Subject: Old American Zinc Plant Superfund Site, Fairmont City, Illinois
Draft Final Design Report dated March 2016

**EPA COMMENTS ON DRAFT FINAL DESIGN REPORT
DATED MARCH 2016
OLD AMERICAN ZINC PLANT SITE
FAIRMONT CITY, ILLINOIS**

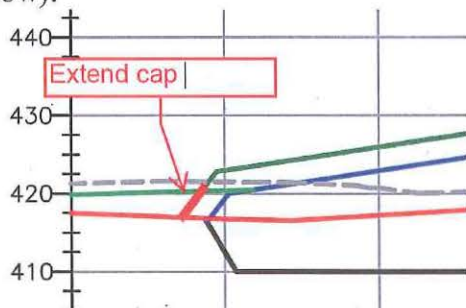
1. Drawings do not have enough detail on them to allow construction.
Please provide:
Survey Control
Staging and stockpile areas
Erosion Control
Control points for excavation and fill
Site Wide cross sections
Removal areas within Rose Creek – while a line on a drawing shows the extent, the detail shows that the width of excavation varies, but no information is provided. How will the constructor know how wide to remediate?
2. Drawing 8, Section B: On the left side, extend cap down to meet clay surface (see figure below):
